Longitunal Door Aggregate Car Aggregate Center Partition Reinforcement Addition Issued Date 09/22/2020

This procedure was developed for orders 160031 and may not be applicable to all car types.

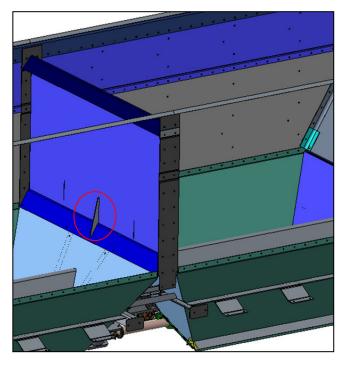
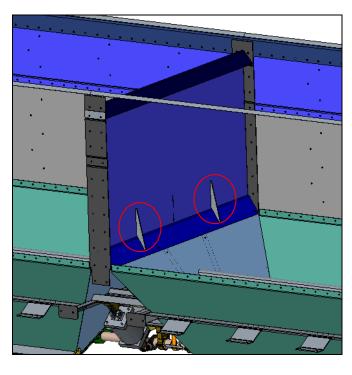
Description – Addition of three reinforcement gussets to center partition to increase strength of cracked weld were center partition and cross ridge cap meet caused by corrosion.

- 1. Clean all debris away were center partition and cross ridge cap meet. Both sides of partition.
- 2. Repair any cracks by grinding and rewelding center partition to cross ridge cap.
- 3. Position part number M116397-000 per drawings below. Areas must be ground and clean of corrosion.
- 4. One gusset centered one side and the other two spaced per dimensions below on the other side. (Doesn't matter which side the single or double gussets are placed)
